Re: Connecticut Humane Society – Application for Special Permit and Site Plan Review
(SP#480) and Application for Regulation Amendment (REG#21388)
Premises: 863-875 Danbury Road, Wilton, CT

As attorney for Connecticut Humane Society (“CHS”), this letter sets forth our responses to the comments and questions contained in Director Wrinn’s email dated July 30, 2021. In support of those responses, either for reference or because they have been amended, I enclose one (1) copy each of the following:

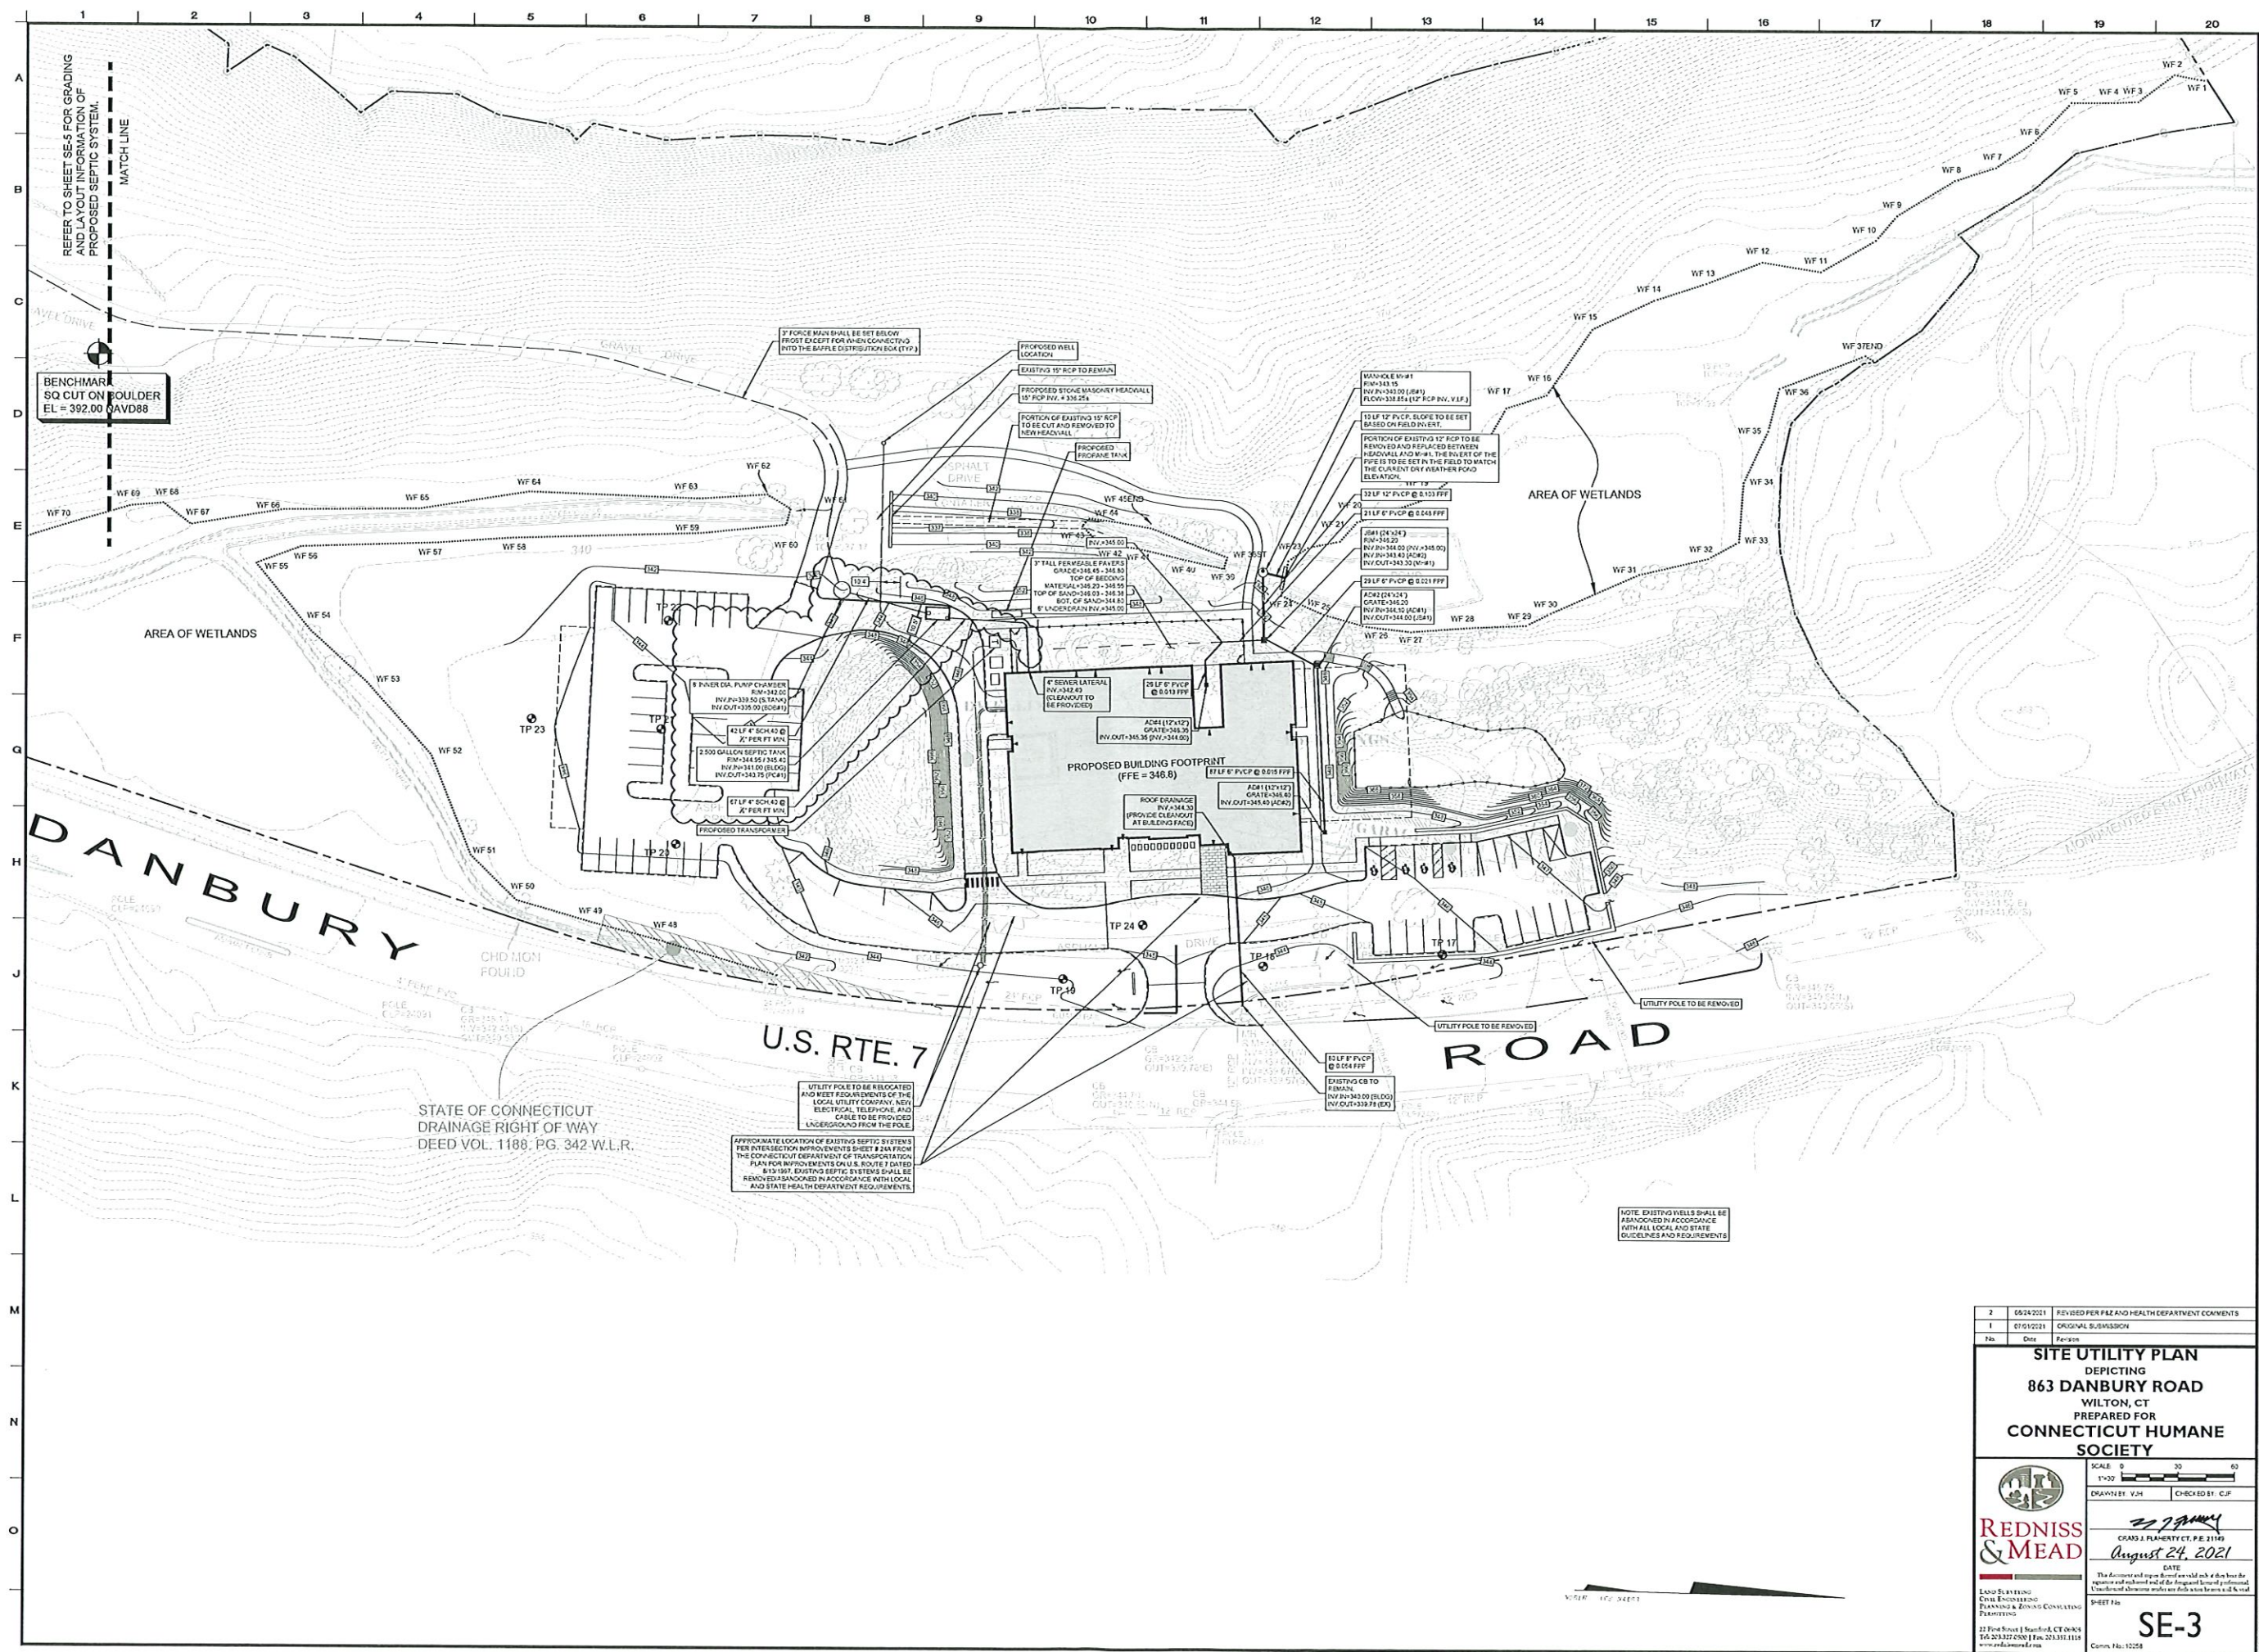
Comment #4: Some of the proposed grading, in the steepest areas seem to be just over the maximum allowable (Section 29-9.I.3).

Response: *It is CHS's intention to grade areas in compliance with Section 29-9.I.3 to the maximum extent possible. If CHS discovers that it is unable to meet the regulatory requirements set forth in Section 29-9.I.3, CHS will instead install retaining walls as described in Site Grading Plan (SE-2) from R&M, dated July 1, 2021, revised August 24, 2021.*
